CITY PLANNING COMMISSION

APPLICATION: A. Special Permit to construct a duplex on a R-1B lot

LOCATION: 2528 C Street

APPLC. NO. __P84-367

EXHIBIT E

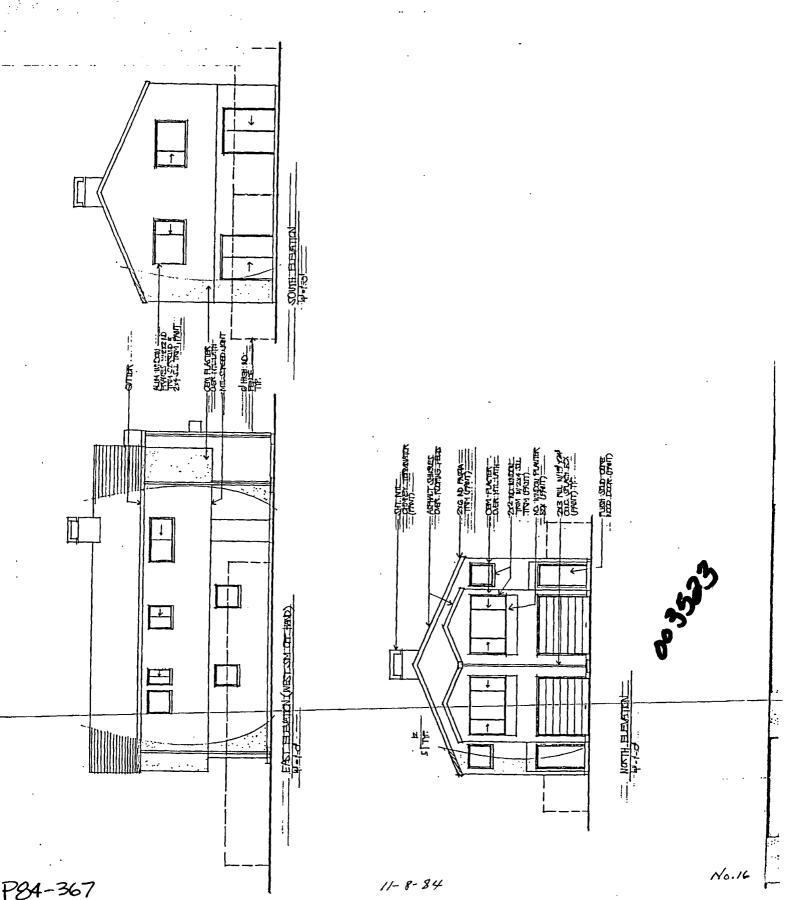
- E. The staff of the Design Review Board is concerned with the exterior elevations and its compatibility with adjacent residential structures. Staff would suggest that the building/elevation plans of this structure be reviewed by the Design Review/Preservation Board. (deleted by staff)

- E. Staff, however, was concerned with the exterior elevations and its compatibility with adjacent residential structures. Therefore, the applicant has submitted revised plans indicating shiplap wood siding, wood garage doors and a roof overhang. Also, a lattice element was designed into the two dormers. The staff of the Design Review Board has indicated that these revised plans would be acceptable and the elevations would be compatible with adjacent structures. (added by staff)

- 1. The applicant shall obtain a driveway permit from the Traffic Engineering Division;
- 2. The applicant shall provide separate water and sewer services for each unit as required by the City Public Works Department;
- The applicant shall extend water and sewer mains to service each unit, if necessary;
- 4. The applicant shall submit project plans to the Design Review/Preservation Board for review and comment. The applicant shall comply with any conditions set forth by the Design Review Board prior to the issuance of building permits. (deleted by staff)
- 4. The applicant shall utilize the revised elevations (Exhibit F) for the proposed duplex. (added by staff)
